Landscape Referral Response

Application Number:	DA2019/1190
Date:	02/07/2020
Responsible Officer:	Daniel Milliken
Land to be developed (Address):	Lot 1 DP 651395 , 9999 Pittwater Road BROOKVALE NSW 2100 Lot 1 DP 784268 , 9999 Pittwater Road BROOKVALE NSW 2100 Lot B DP 966128 , 9999 Pittwater Road BROOKVALE NSW 2100 Lot 6 DP 785409 , 9999 Pittwater Road BROOKVALE NSW 2100

Fig. 1 TPZ & SRZ overlay

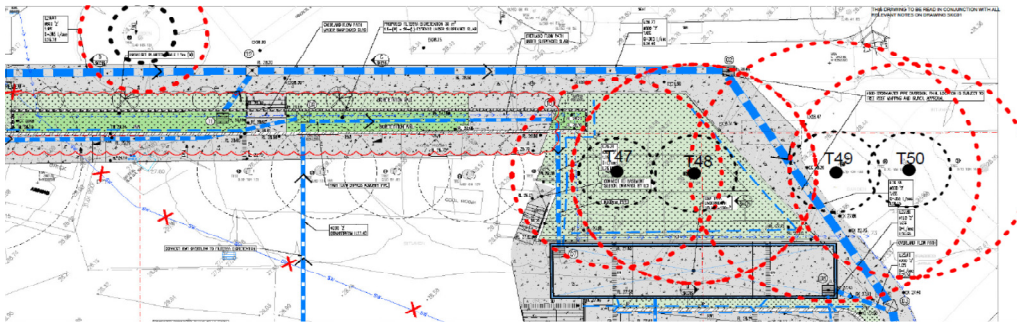
Concern is raised with regard to the impacts on trees proposed for retention adjacent to the stormwater works shown on the Storm Water and Site Works Concept Plan Dwg No. C05-2 A prepared by TTW.

Review of the proposed works in accordance with AS4970-2009 *Protection of trees on development sites* indicates significant impacts on Trees T47, T48 and T49 which would render them unsuitable for retention. Fig. 1 below indicates the Tree Protection Zone (Red dash circle) and Structural Root Zone (Black dash circle) overlaid on to the stormwater drawing.

Based on the TPZ of each tree as identified in the applicant's Arborist report, the following impacts have been calculated.

T47: TPZ radius 7.9m; TPZ area 196m²; Works incursion 74m² = **38% of TPZ**

T48: TPZ radius 9.2m; TPZ area 266m²; Works incursion 125m² = **47% of TPZ**

T49: TPZ radius 10.9m; TPZ area 373m²; Works incursion 74m² = **37% of TPZ**

These impacts are considered too great to enable retention of trees T47, 48 and 49.

Fig. 2 Swept path
drawing

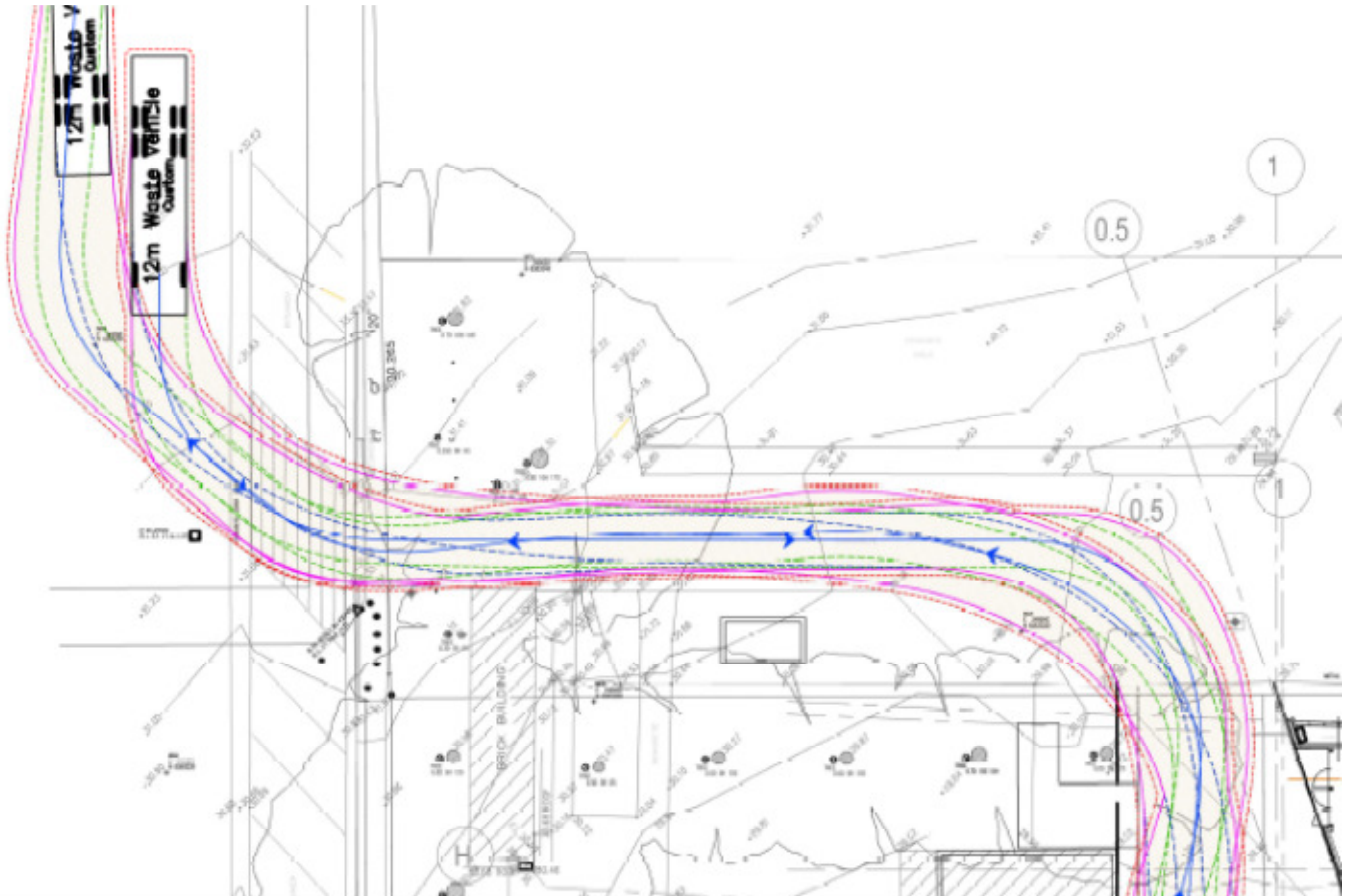
A drawing has been provided indicating the swept path for waste service truck to access the site (Fig 2 below). Several trees (including one heritage listed tree) are close to the routes indicated and it is

unclear if additional hard paving areas are required to accommodate the trucks. It is likely that additional pruning would be required and there is potential for ongoing trunk damage given the close proximity of the tracked path to the tree trunks. The existing entry arrangement is indicated on Photo 1 below. This may be able to be addressed through further information, however the plan again highlights the ongoing impact of the development on the existing trees.
